ADDENDUM NO. 2

WASHINGTON STATE PARKS AND RECREATION COMMISSION
WILLAPA HILLS STATE PARK TRAIL
MENLO TRAILHEAD
NW-C1219

DATE: June 04, 2025

Brett Taylor, Procurement Coordinator
Contracts and Grants Program

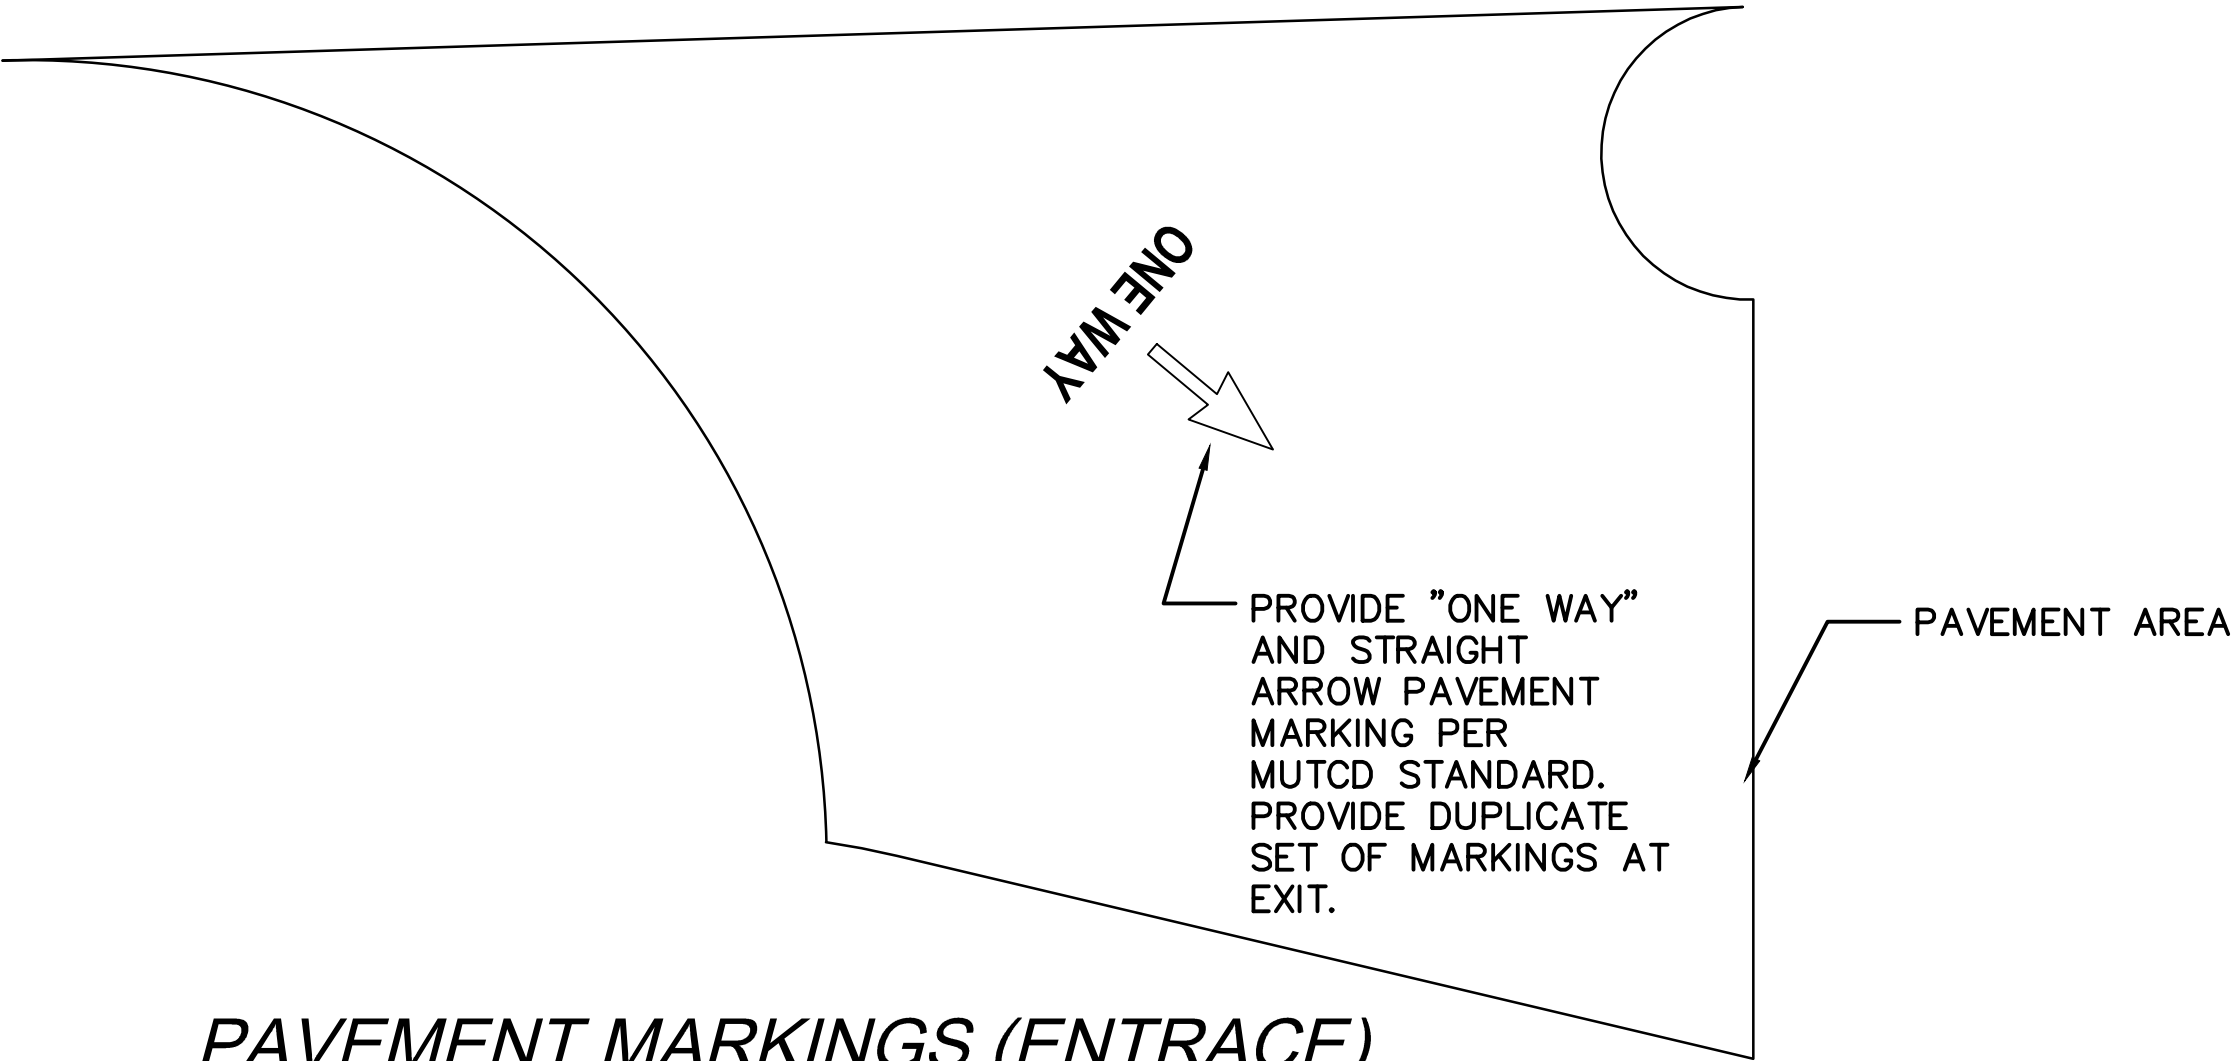
Sheet 7 Revise: RETAINING WALL NOTES:

Line 5: Remove the word "NO" and add: SEE SPECIFICATIONS

Line 6: Remove the word "NO" and add: SEE SPECIFICATIONS

- RETAINING WALLS MUST BE INSTALLED AND CONSTRUCTED ACCORDING TO THE CONTRACT DRAWINGS.
- CONTRACTOR SHALL VERIFY THE ACTUAL LENGTH OF RETAINING WALL ONSITE.
- RETAINING WALL UNITS AND INSTALLATION SHALL CONFORM TO THE ELITE KELLEY BLOCK (LEGATO BLOCK) RETAINING WALL SYSTEMS SPECIFICATIONS GUIDELINES. OR APPROVED EQUAL.
- BACKFILL NATIVE SOIL BEHIND THE RETAINING WALL
- ~~NO~~ GEOGRID IS REQUIRED SEE SPECIFICATIONS
- ~~NO~~ DRAIN PIPE IS REQUIRED BEHIND THE WALL SEE SPECIFICATIONS
